1R - 426-04

**RE: CAP Report and Termination Request
for the Rice Operating Company's
BD M-26-1 Site
Unit Letter M, Section 26, T21S, R37E, NMPM, Lea County, New Mexico
Remediation Plan (1R426-04) Termination**

**RE: CAP Addendum for the Rice Operating Company's
BD M-26-1 Site
Unit Letter M, Section 26, T21S, R37E, NMPM, Lea County, New Mexico
Corrective Action Plan Addendum (1R426-04) Approval**

BD M-26-1

Proposed Liner

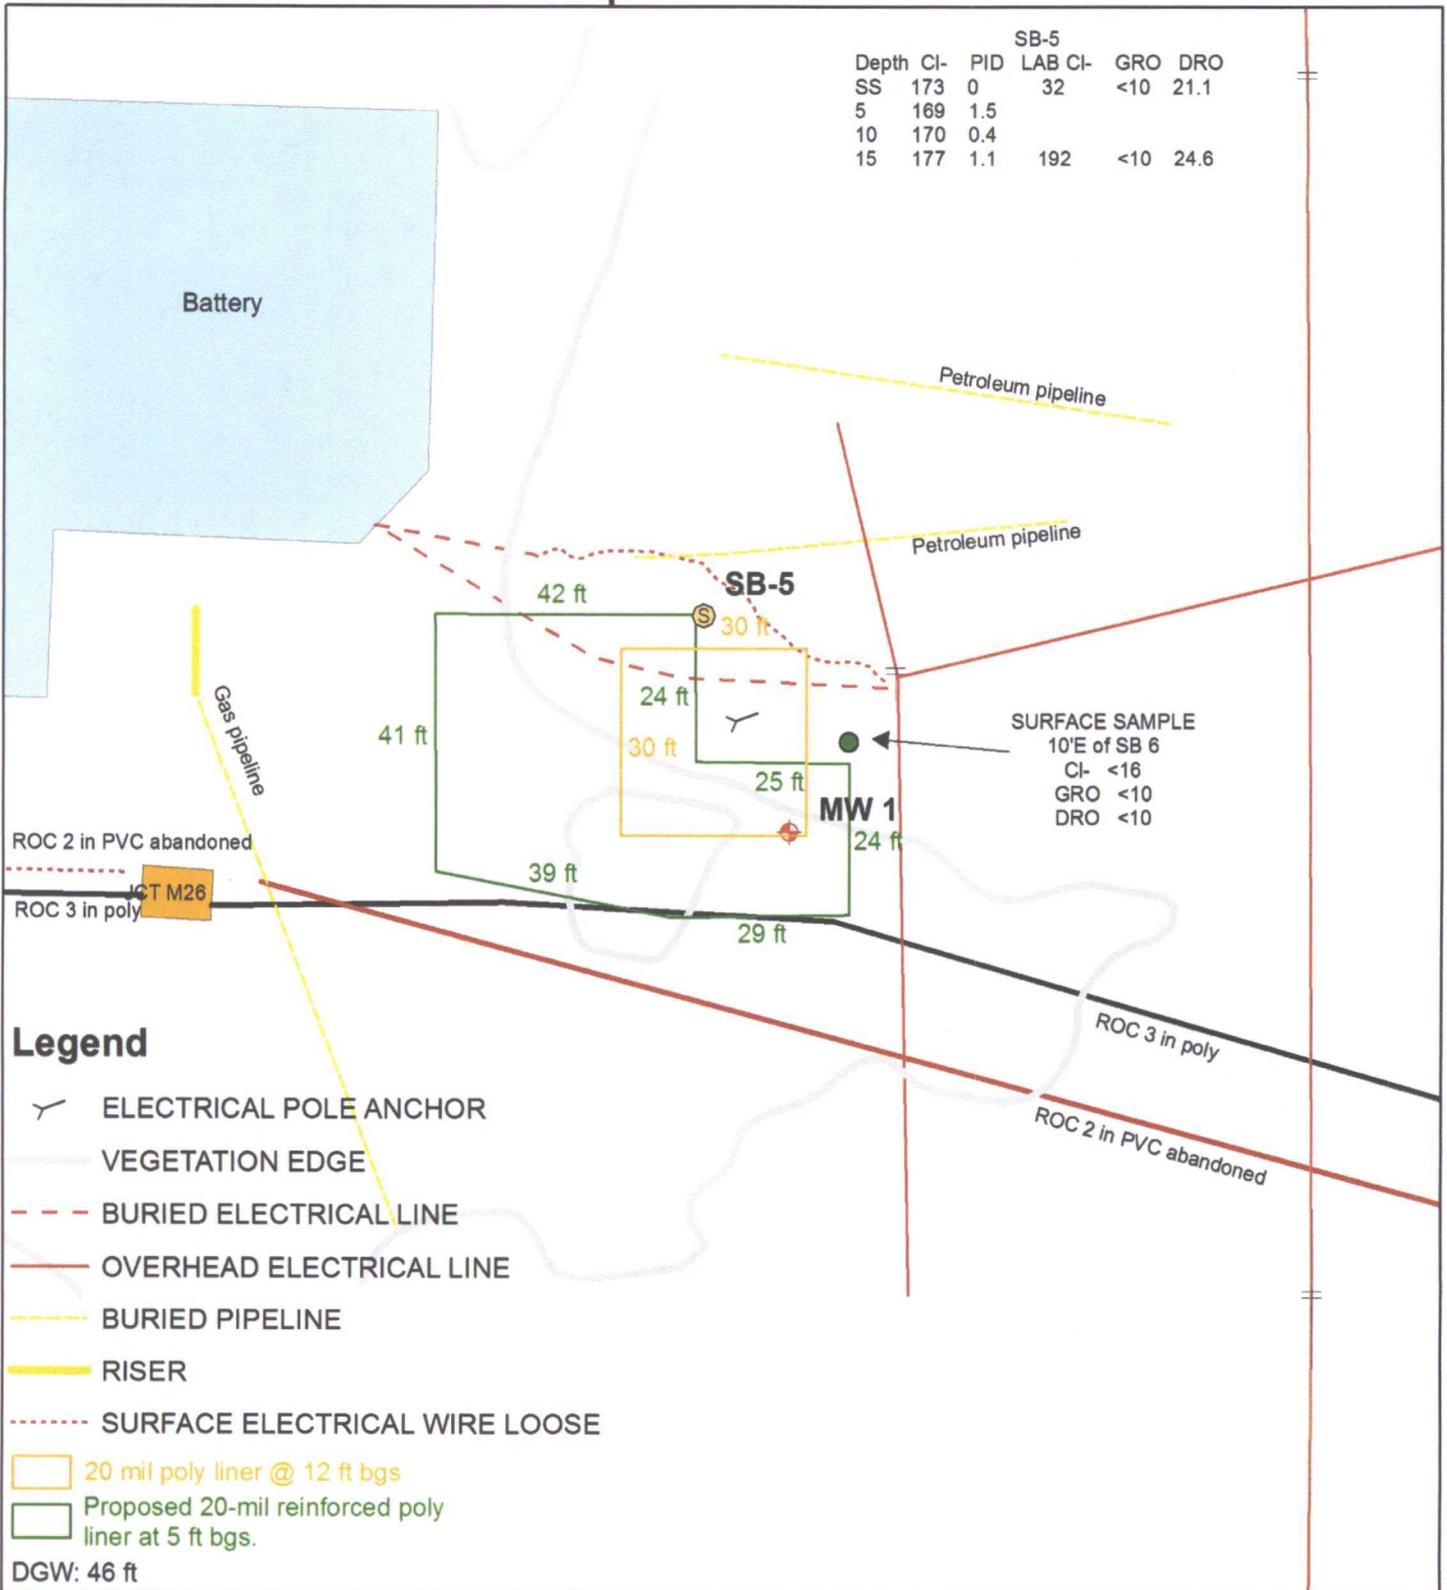
ROC submits the following as an Addendum to the BD M-26-1 (1R426-04) CAP approved by the NMOCD on June 27, 2012. Due to an electric pole and anchor being located within the approved excavation, ROC proposes to modify the liner dimensions to reflect the attached plat. Excavating around the electric pole and anchor is a safety hazard. The liner will have a 24x25-ft area cut out of the northeast corner. Chloride concentrations in that area are low, less than 192 mg/kg throughout SB-5. TPH concentrations are also low in SB-5. A surface sample collected in the area, resulted in a chloride and TPH concentrations below detectable limits. The existing 30x30-ft liner covers the area beneath the anchor. Vegetation surrounding the electric pole and anchor has recovered. Photographs showing the electric pole, the anchor, and healthy vegetation are attached. If you have any questions or require any additional information, please contact Hack Conder at (575)631-6432.

- 20 mil poly liner @ 12 ft bgs
- Proposed 20-mil reinforced poly liner at 5 ft bgs.
